ADDENDUM NO. 1

South Putnam Middle School/High School Fieldhouse Addition

Project No. 222152.03

Date: June 13, 2024

E-502

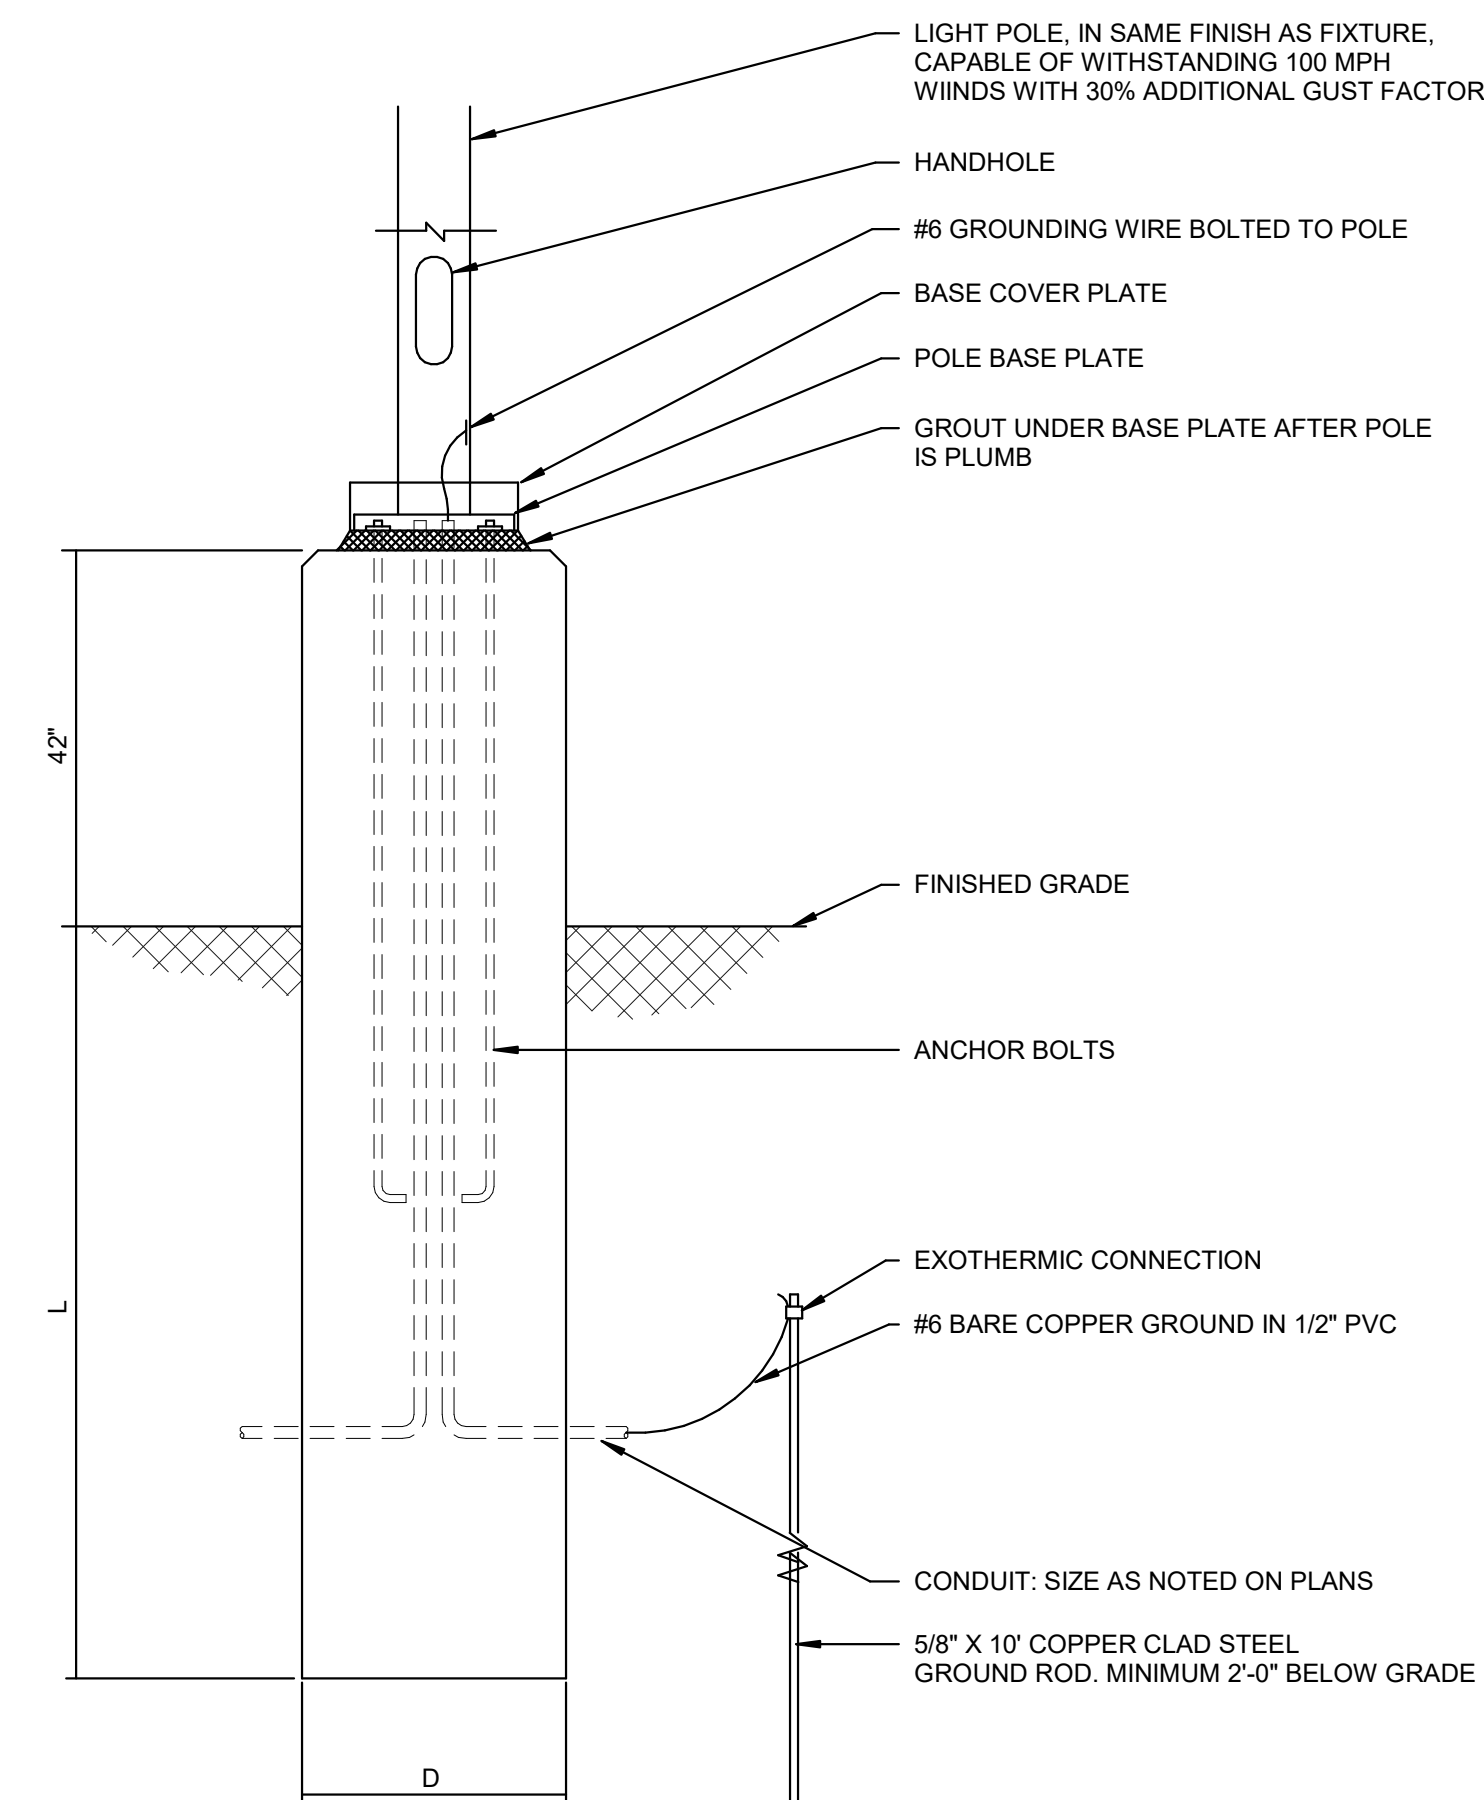
- A. Drawing Sheet No. E-502 – Electrical Details, dated 6/12/24, is included with and hereby made a part of this Addendum.
